**To:** John Tunstall, P.E.  
**From:** Pat O'Mahony, Associate Planner; 910-341-0189  
**CC:** File;  
**Date:** 7/30/2019  
**Re:** Renaissance Apartments TRC Review

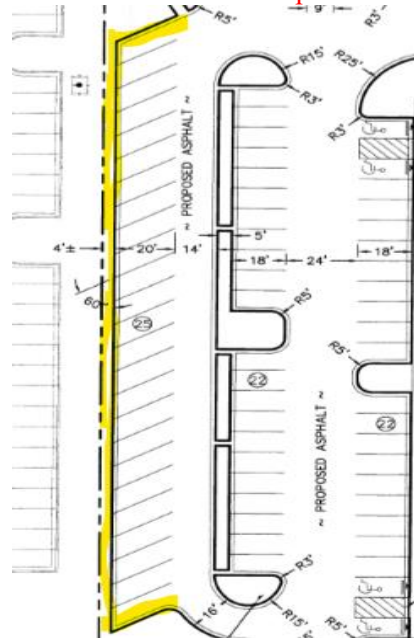
- **Off street parking calculations, including required amount of parking and proposed amount of parking and the basis for determination**
    - **Comment: Parking area on SE corner looks to be over the property line, please explain. See area highlighted in the image below:**

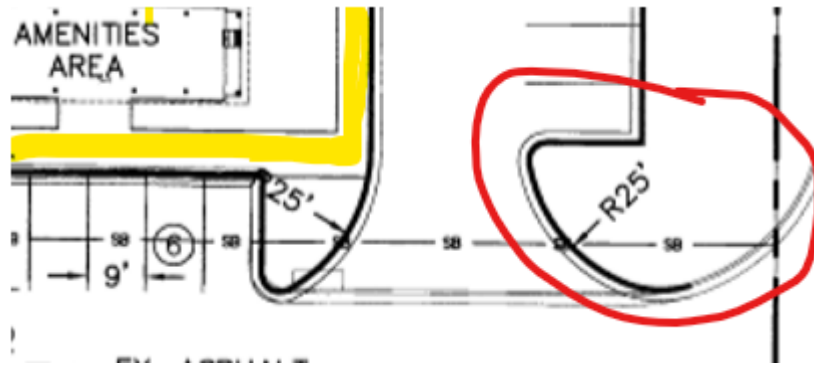
- Comment: Parking area shown below must incorporate landscaped islands at the ends of all parking rows and within the rows, such that no parking space is located more than one hundred twenty (120) feet from a planting island or peninsula. Review indicates that not all spaces may be within 120' of a landscape island.
